This report has been prepared in response to NUREG-0737 item 1.D.1 and details the means by which a Detailed Control Room Design Review was conducted for the Turkey Point Units 3 & 4 Nuclear Power Plants owned and operated by the Florida Power & Light Company. The review was conducted using NUREGs-0700 and -0801, and spanned the period from July 1981 to July 1983.

**FIGURE 2.3.1-4**  
**SOUND LEVELS (dB(A)) WITH CONTRIBUTED NOISE FROM UNIT SHARED ANNUNCIATOR**

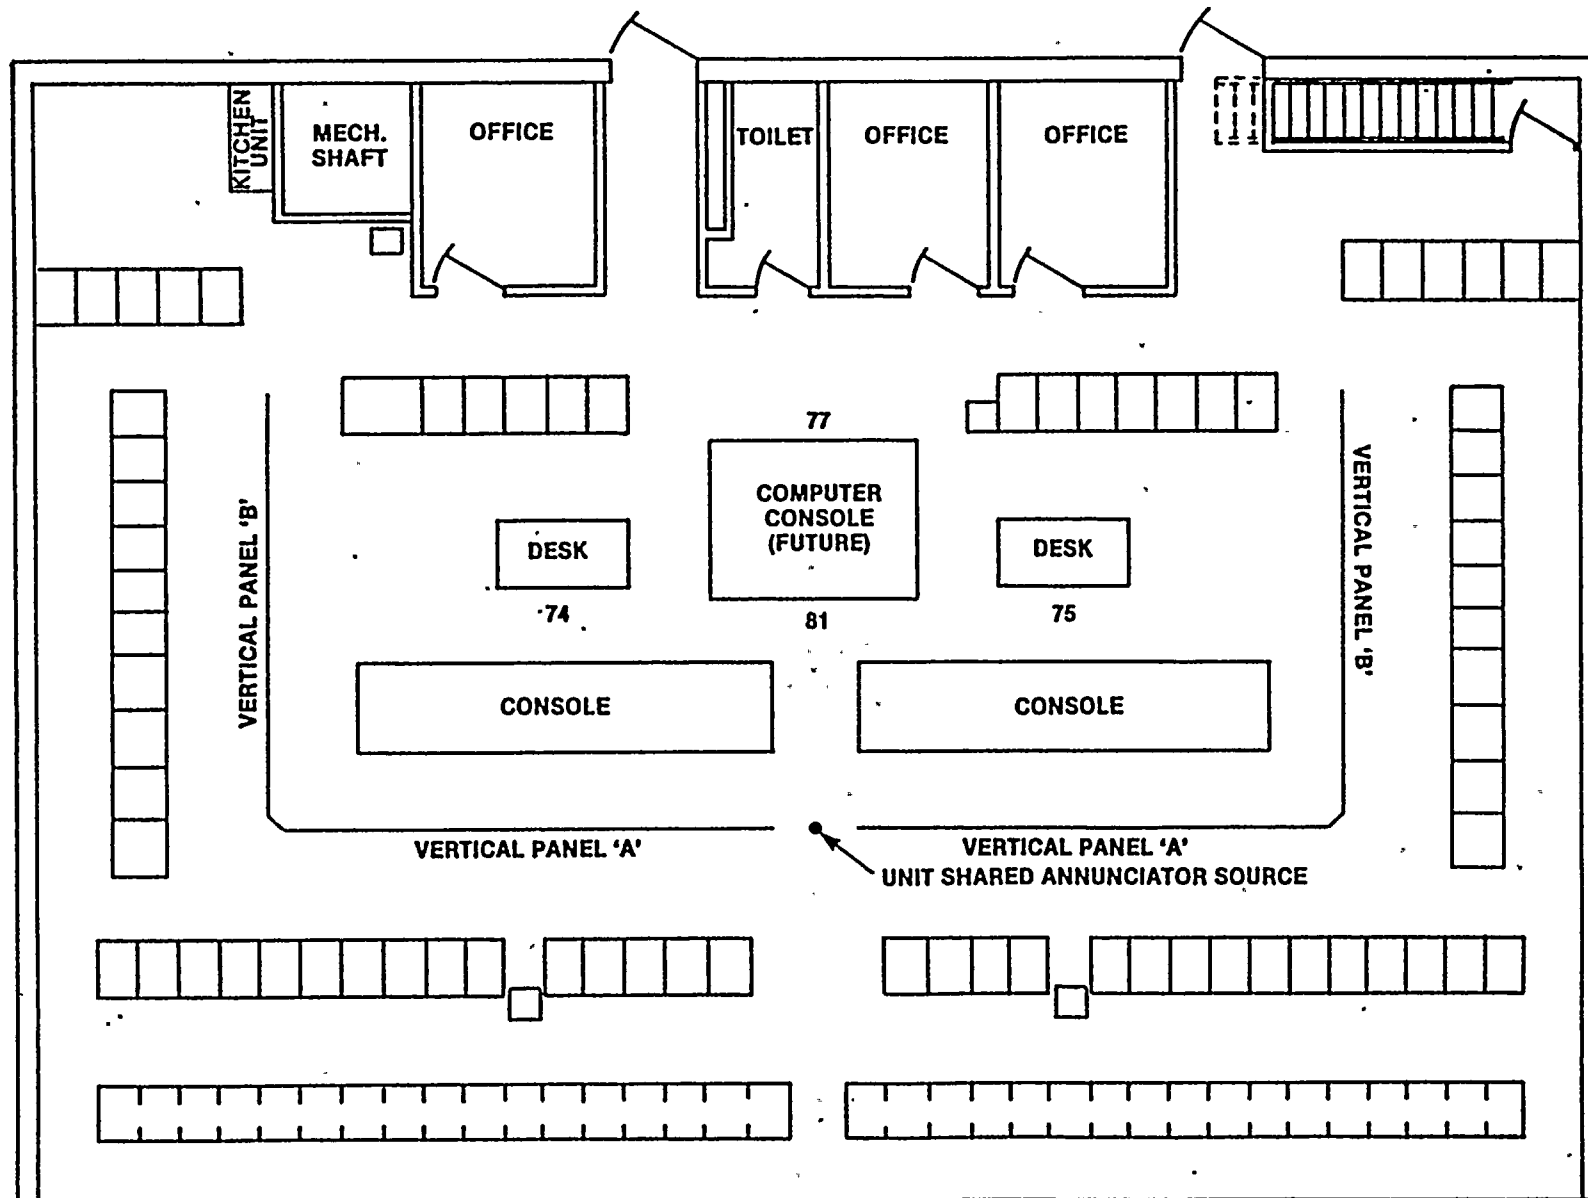
For all measured audible alarms, except the Unit 3 annunciator audible, the alarm signal intensity (for the signal frequency) was greater than potential ambient masking frequencies for the same and adjacent lower ambient frequencies (see table below).

- o Increase both the signal integrity and frequency of the Unit 3 annunciator alarm
- o Provide, if feasible, sound attenuators such as carpeting to reduce ambient control room noise
- o Isolate and attenuate, if possible, the sources of low frequency noise in the control room.

**FIGURE 2.3.2-3**  
**ILLUMINATION LEVELS USING BLUE FLORESCENT LIGHTS OVER VERTICAL PANELS**  
**(FOOT-CANDLES)**

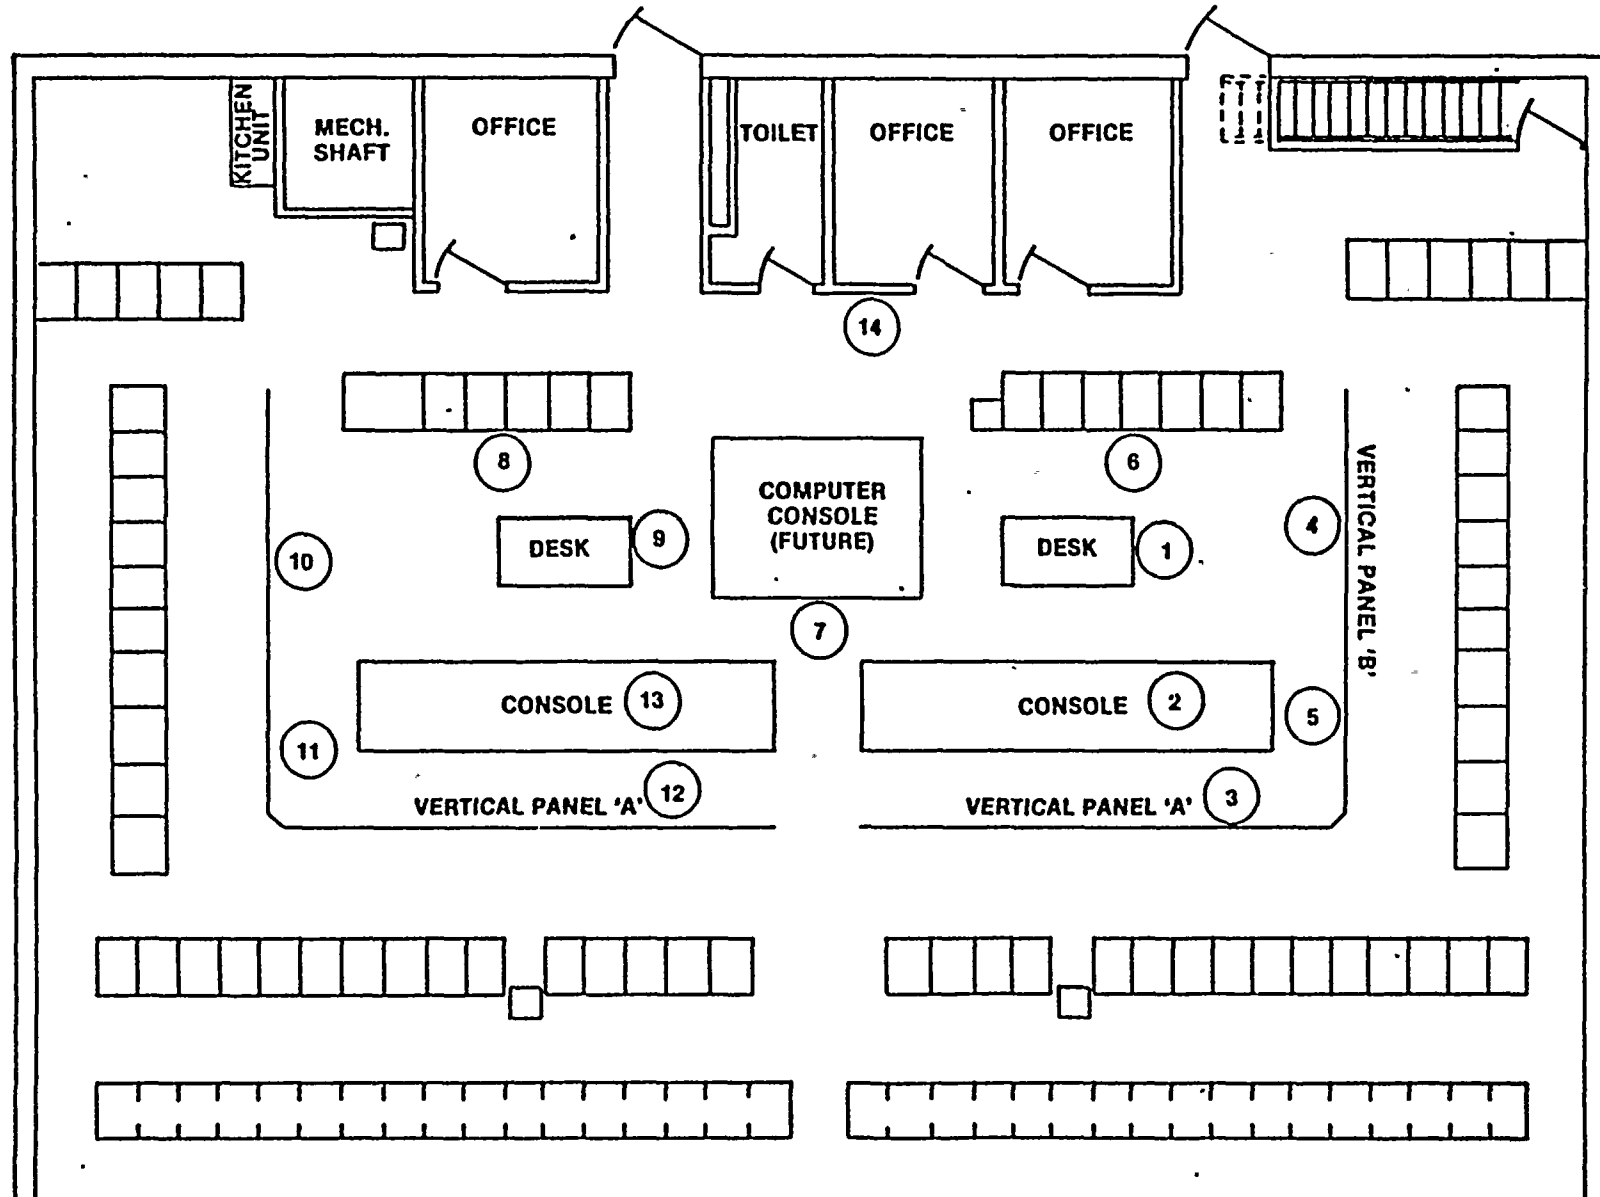
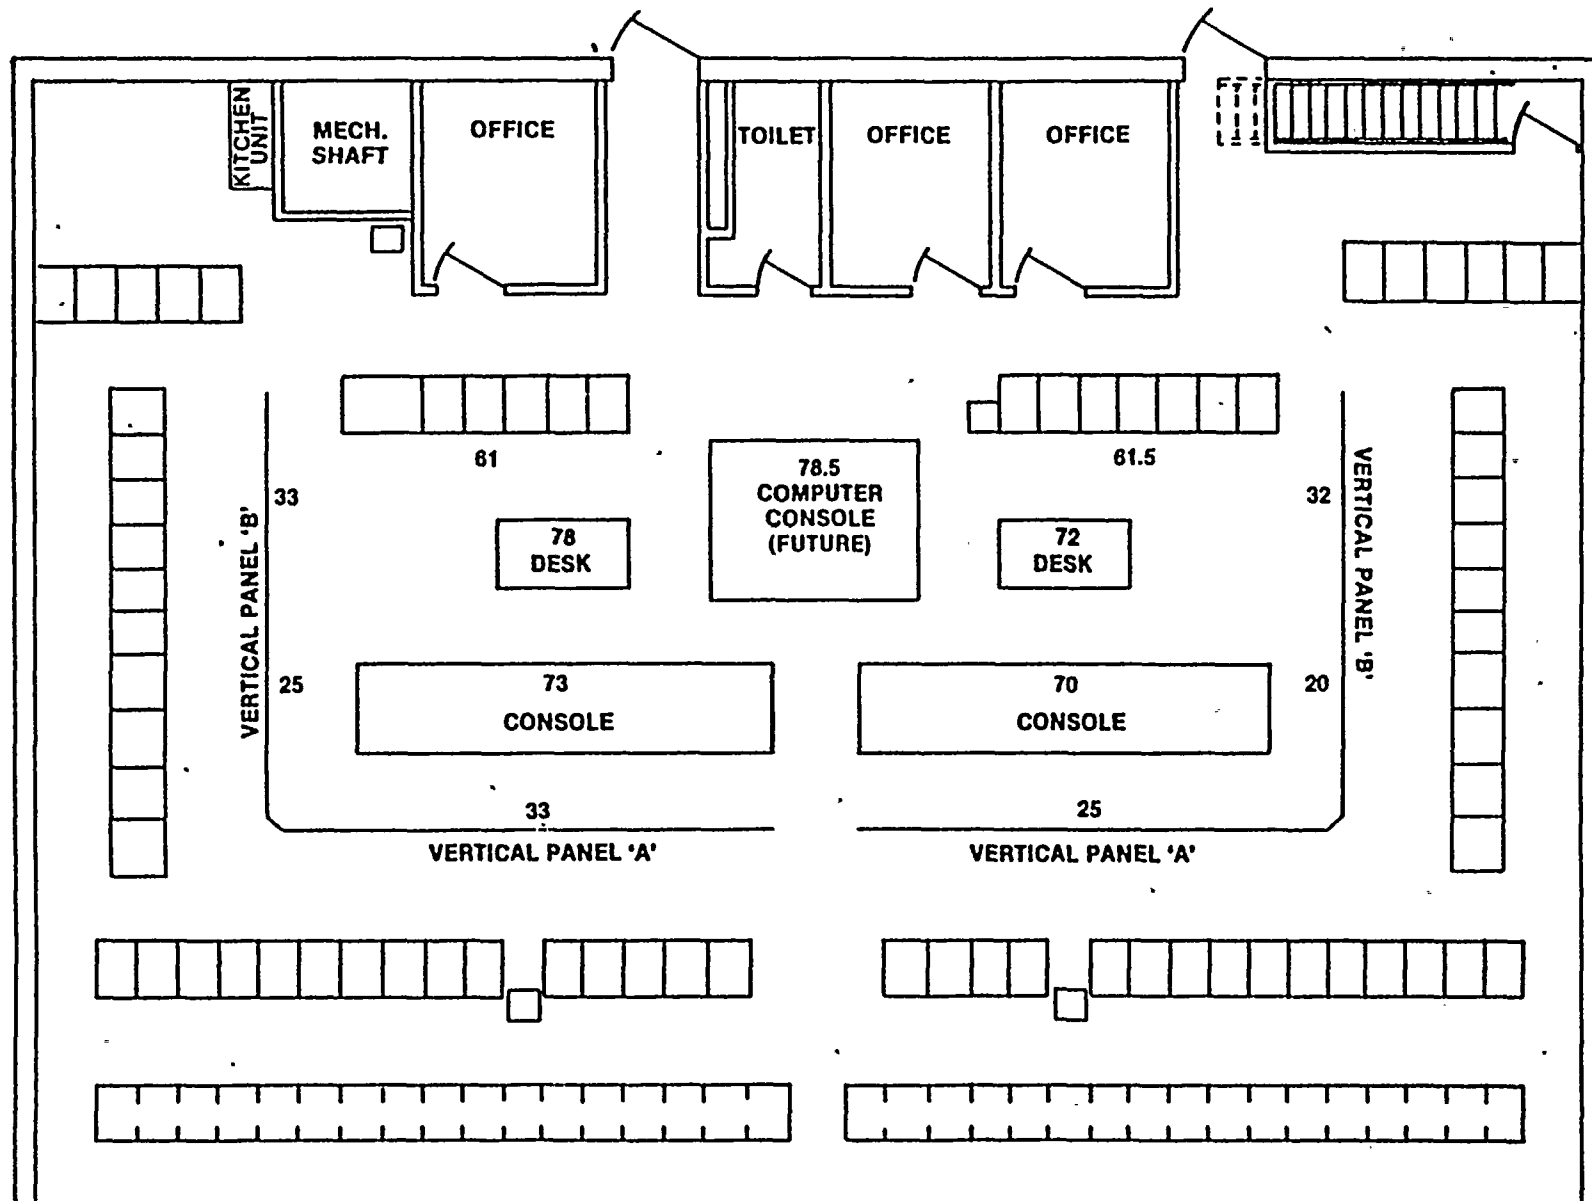
**Illuminance** — The normal ambient illumination exceeded the levels recommended in the NUREG-0700 guidelines at most work stations (see Figure 2.3.2-2 and Table 2.3.2-2). The emergency illumination was below the minimum guideline values of NUREG-0700 at all operator work stations (see Figure 2.3.2-2 and Table 2.3.2-2).

In response to a preliminary finding regarding illuminance and glare on the vertical boards, Florida Power & Light Company installed blue florescent lights over these panels to reduce both incident lighting levels and glare. The blue florescent lighting was evaluated (the data are summarized on Figure 2.3.2-3) and was found to successfully reduce lighting levels and glare over the vertical panels; however, the blue color had an adverse effect on color coding especially on blue indicator lights (washed out color).

**FIGURE 2.3.3-1**  
**CONTROL ROOM VISIBILITY FROM SHIFT FOREMANS OFFICE**

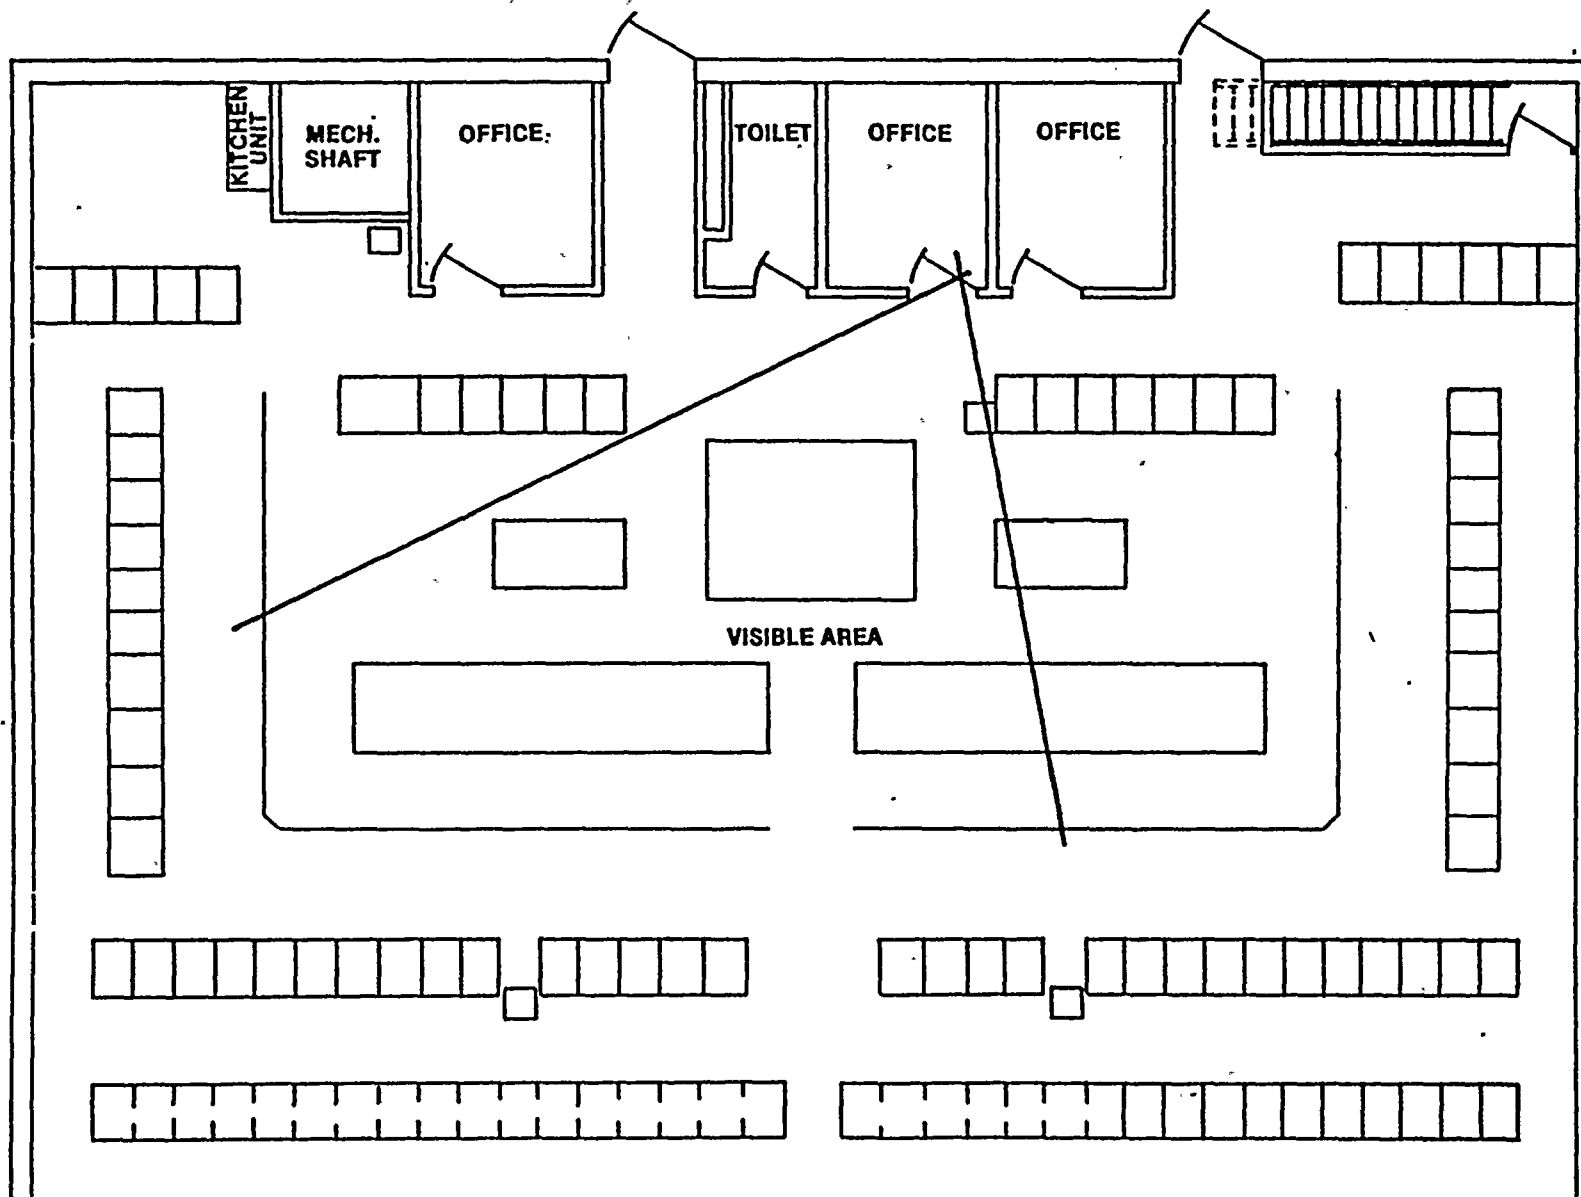
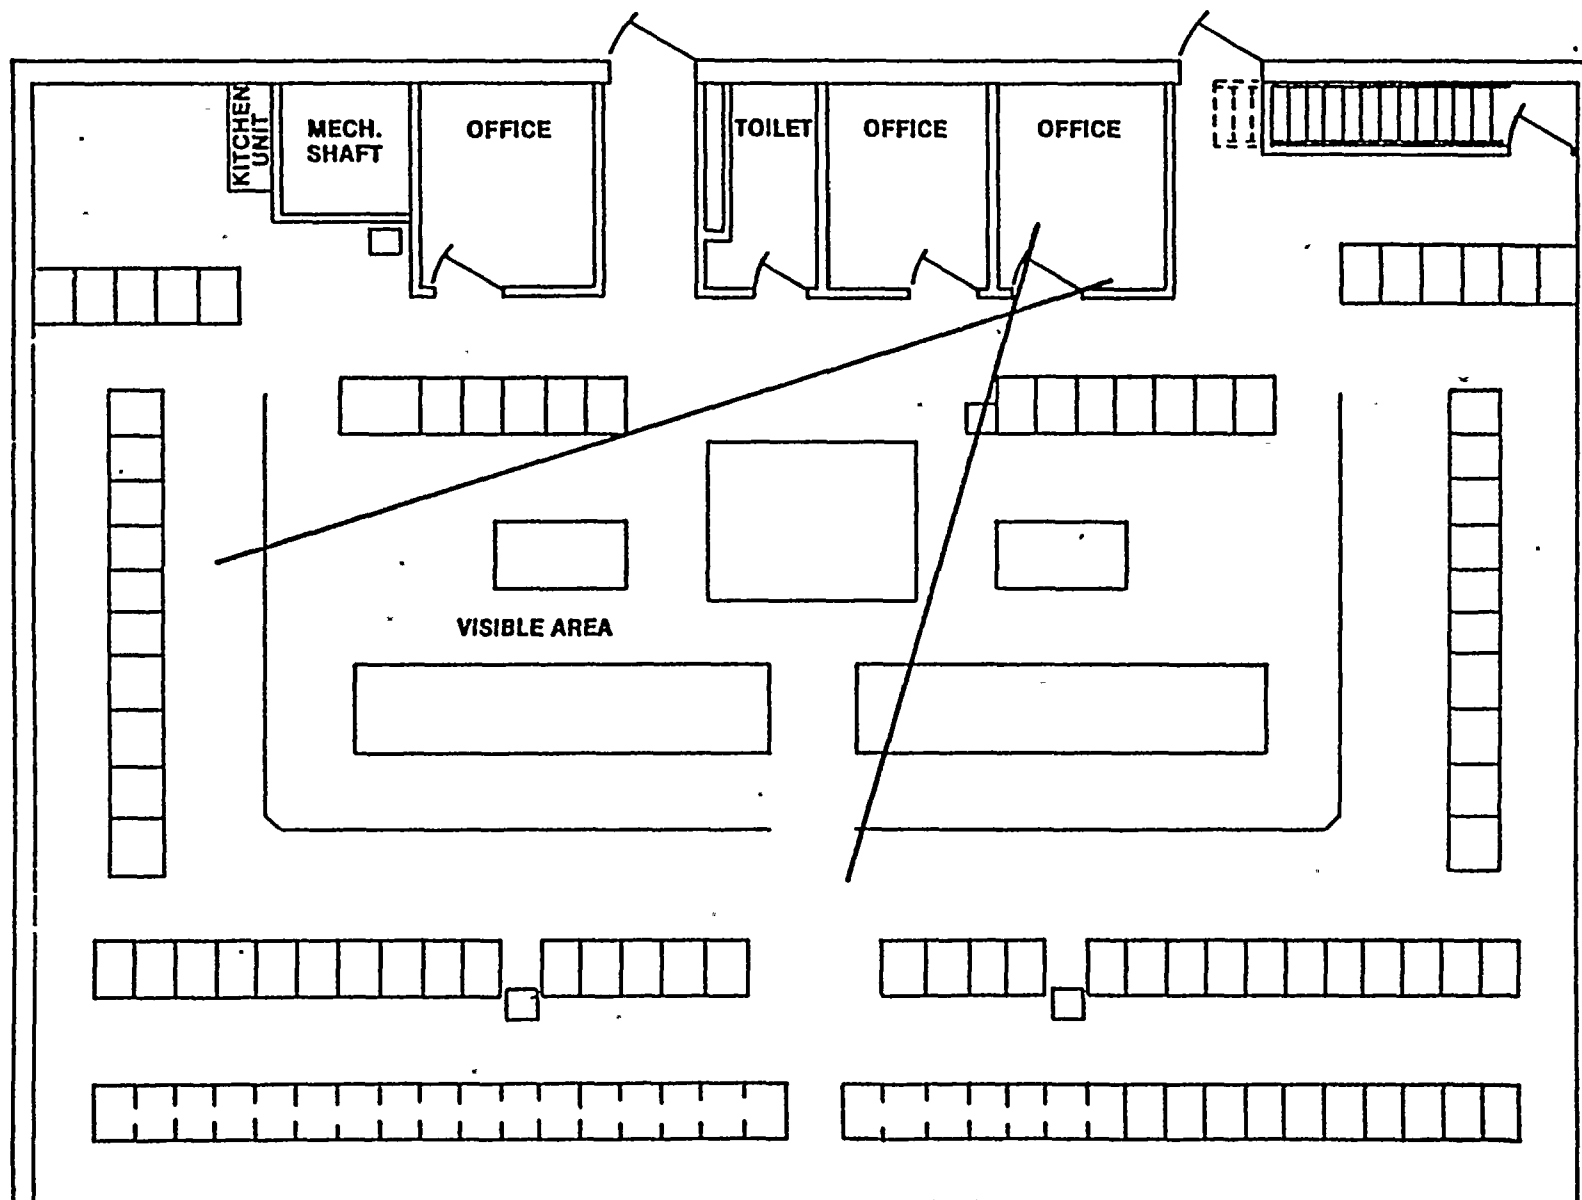
Supervisor Visual Access — Figures 2.3.3-1 and 2.3.3.2 show control room visibility from the shift formen's and watch engineer's offices, respectively. Note that a good deal of each control room is obscured by the nuclear instrumentation system (7-foot vertical) panels. A variety of means to ameliorate these discrepancies have been considered, from "bulging" the offices out into the control room between the nuclear instrumentation system panels to elevating the office floors to a point when visibility over the nuclear instrumentation system panels would be afforded. Florida Power & Light elected to extend the Nuclear Plant Supervisor's office into the control room area, which allows complete control room visibility.
